MARKED-UP CLAIMS ACCOMPANYING RESPONSE TO OFFICE ACTION FOR USSN

09/457,434:

**MARKED-UP PAGES 8 AND 9 OF THE SPECIFICATION SHOWING CHANGES MADE
ACCOMPANYING RESPONSE TO OFFICE ACTION FOR USSN 09/457,434**

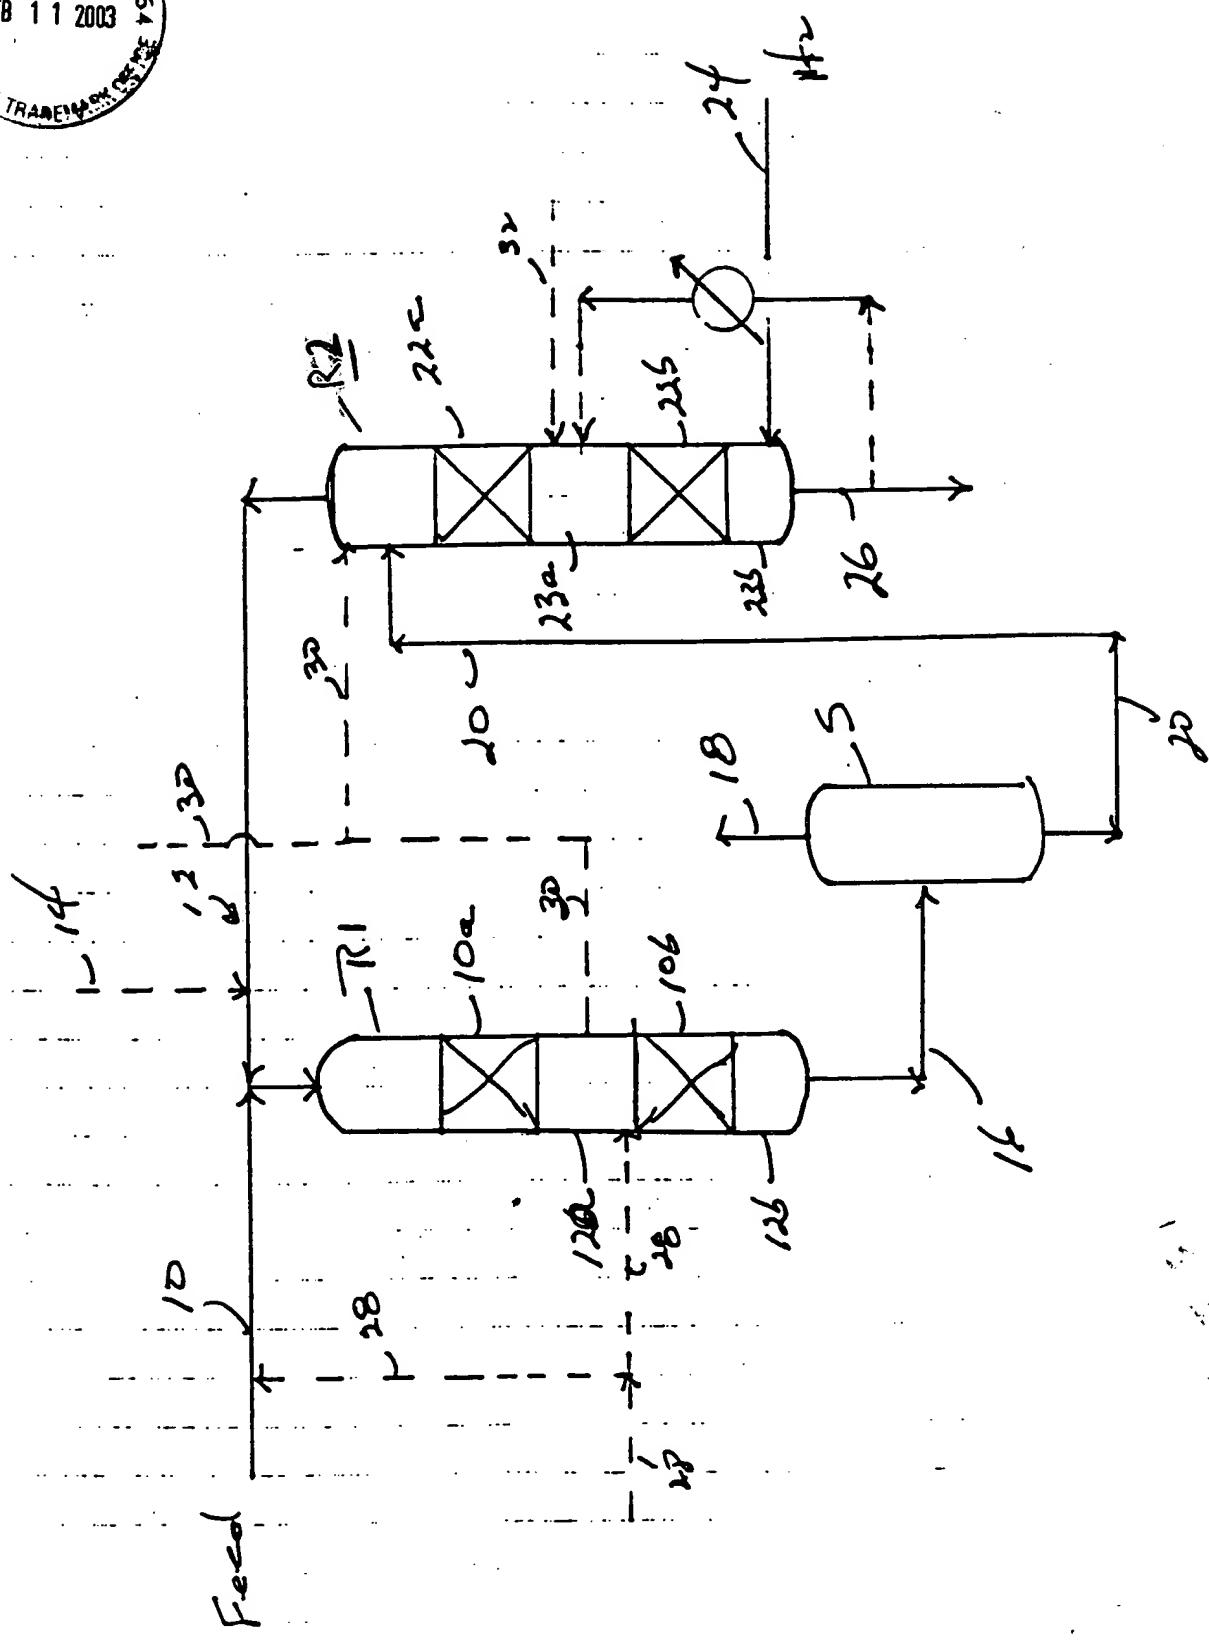
The Figure corresponding to the instant specification has also been amended according to the Examiner's suggestions. Namely, the reference number "R2" has been added to refer to the second reaction stage. No New matter was added.

The Examiner points out that the specification on page 8 teaches that the vapor product stream is collected via overhead line 20 when the drawing gives this line

reference numeral "18". The Examiner also points out typographical errors in the specification.

Page 8 of the specification has been amended according to the Examiner's suggestions. Namely, the second "is" as it appears in the last full sentence of page 8 has been deleted. Also, the reference to the overhead vapor product stream as line "20" has been amended to refer to this stream with reference numeral "18"; this overhead vapor product stream is denoted as such in the attached Figure. No New matter was added.

A combined liquid phase and vapor phase product stream exit reaction vessel R1 via line 16 and into separation zone S wherein a liquid phase product stream is separated from a vapor phase product stream. The liquid phase product stream will typically be one that has components boiling in the range from about 150°C to about 650°C, but will not have a boiling range greater than the feedstream. The vapor phase product stream is collected overhead via line 18.
